THE CITY OF WALTHAM
MASSACHUSETTS

**RECONSTRUCTION OF CHURCH STREET
PARKING LOT**

ADDENDUM NO. 1

November 17, 2017

REVISED 11/17/17

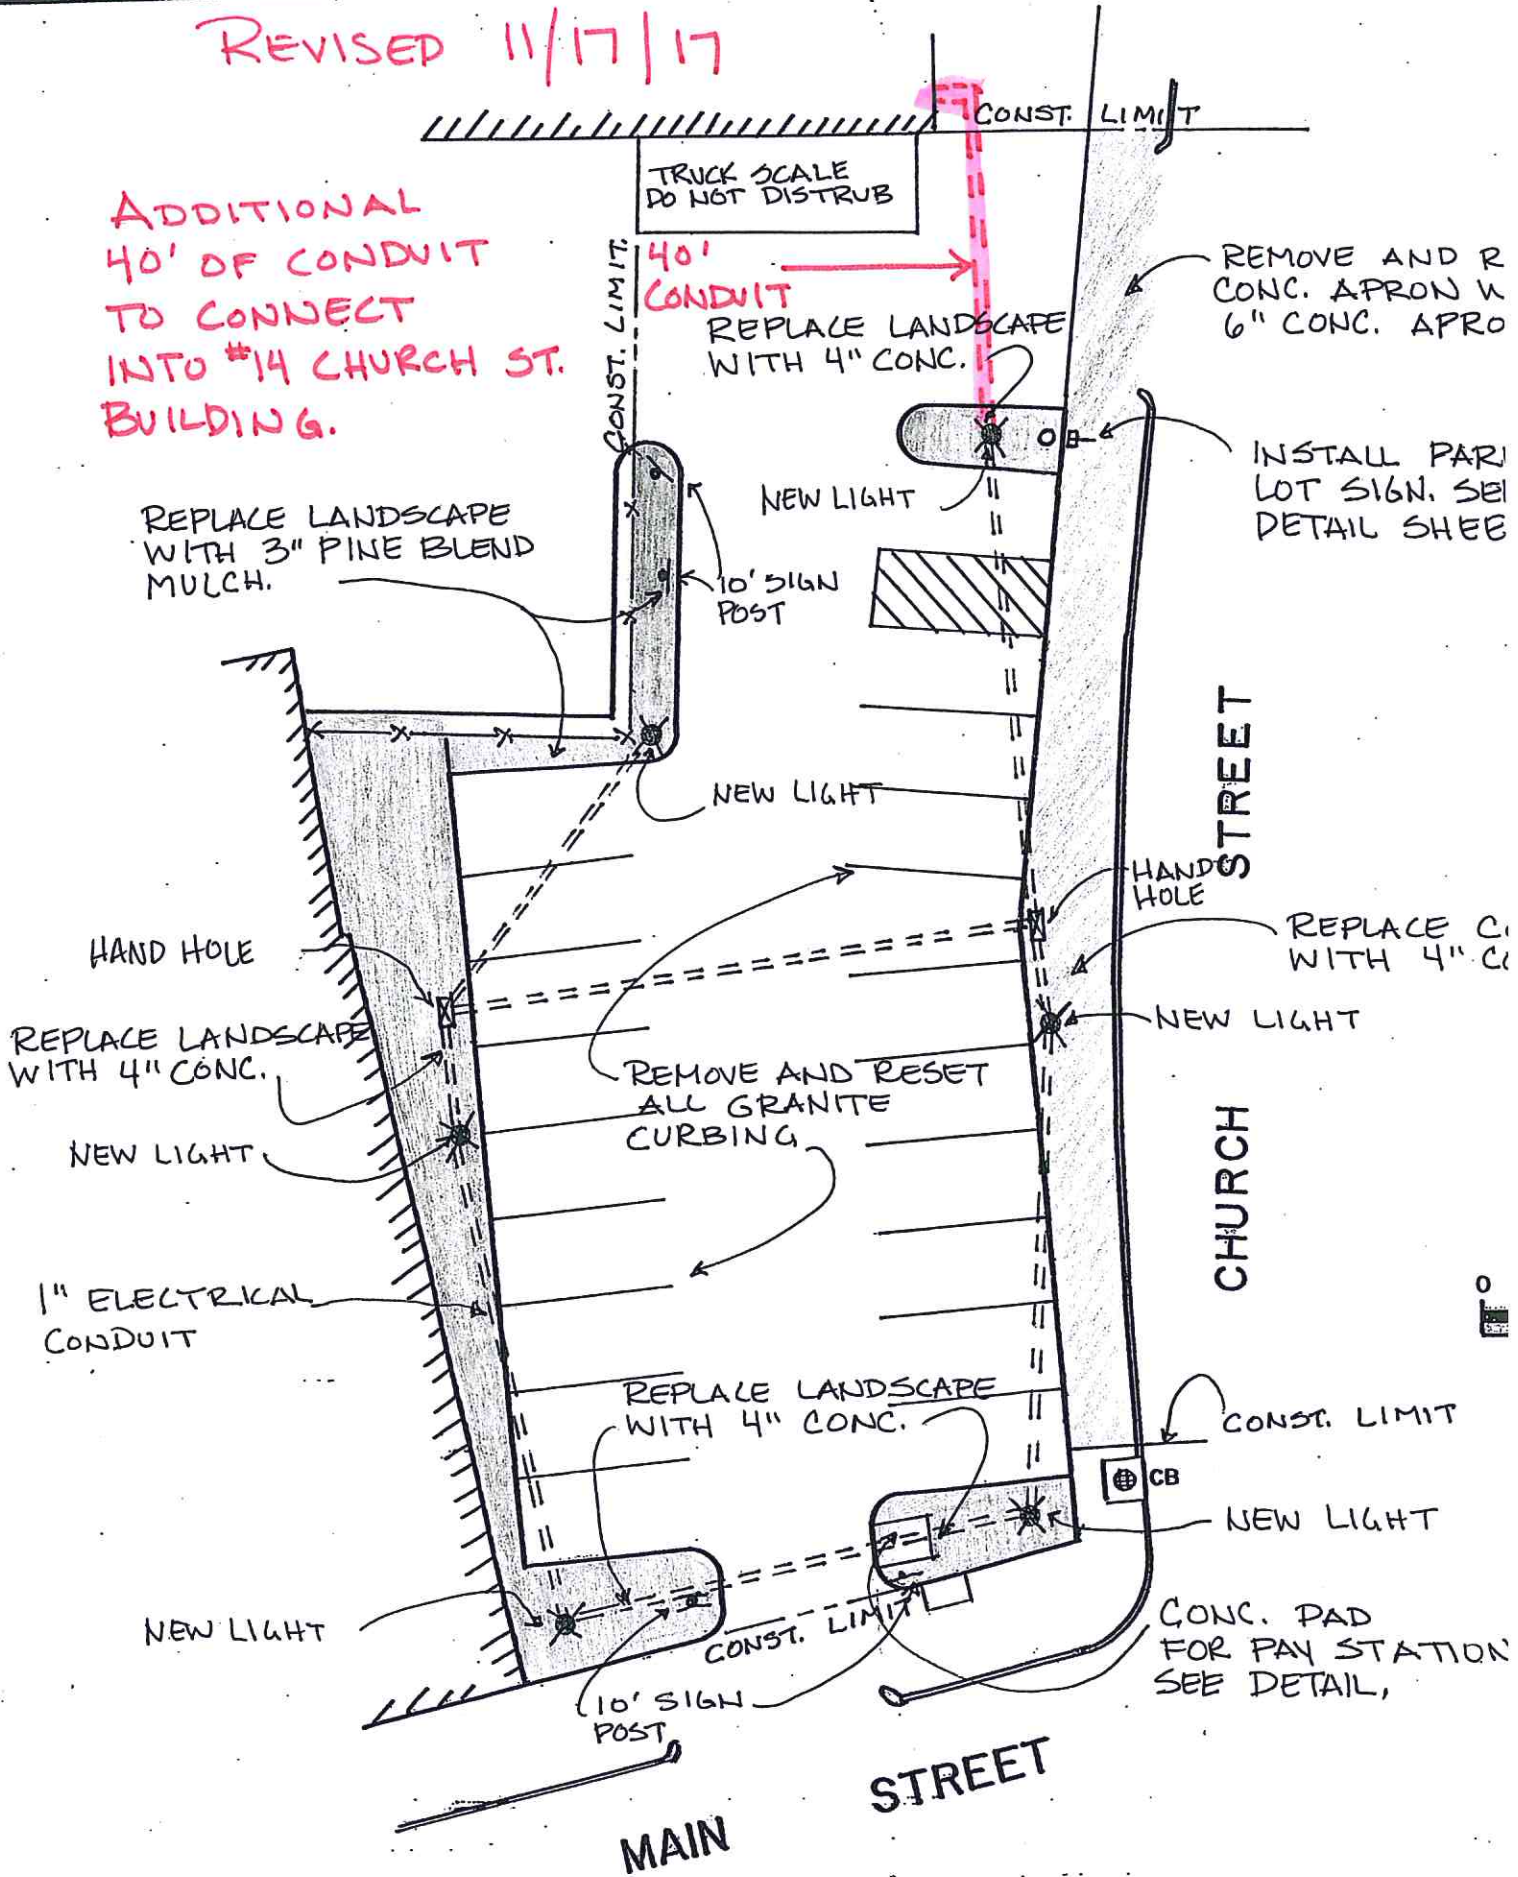
Q1. The plans do not show any conduit connecting the pole to an of the proposed hand-holes. Can you confirm where the power is coming from and if additional conduit is necessary.

ADDITIONAL
40' OF CONDUIT
TO CONNECT
INTO #14 CHURCH ST.
BUILDING.

A1. Please see the attached revised Electrical Conduit Drawing

1 BIT. CONC. ROADWAY & PARKING
L8 N.T.S.

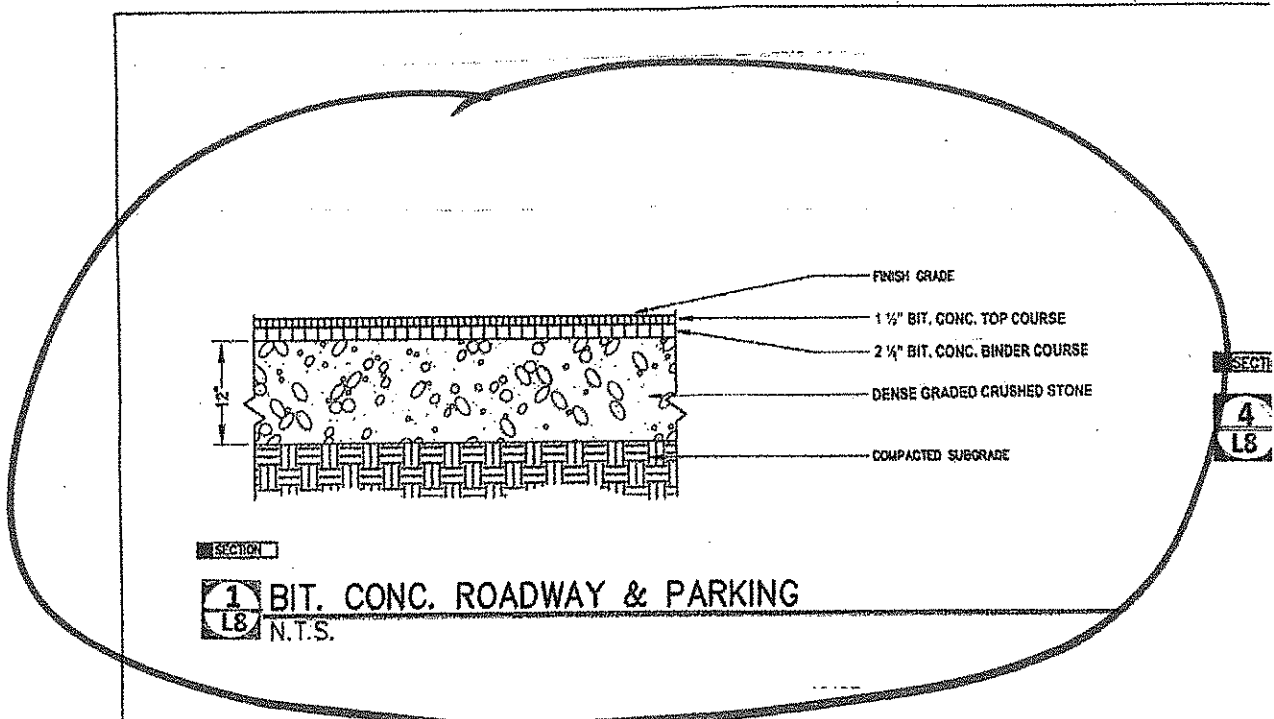
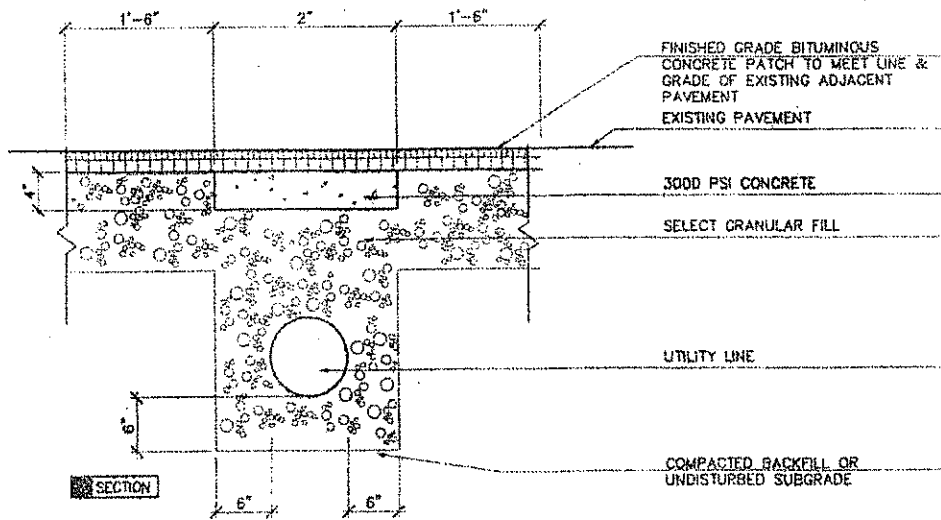
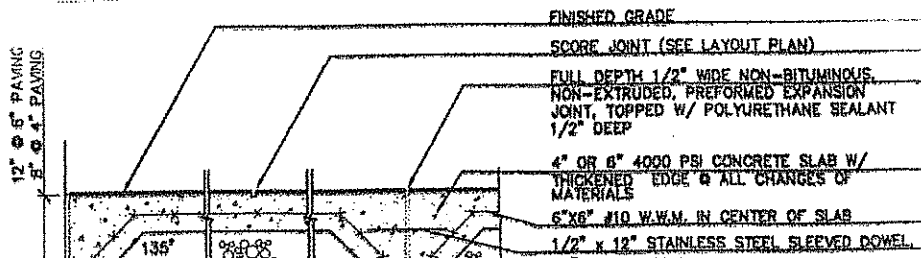
Q2. Can you please provide a detail for the parking lot sub-base and pavement?

A2. Please see the attached Sub-Base & pavement Details Drawing
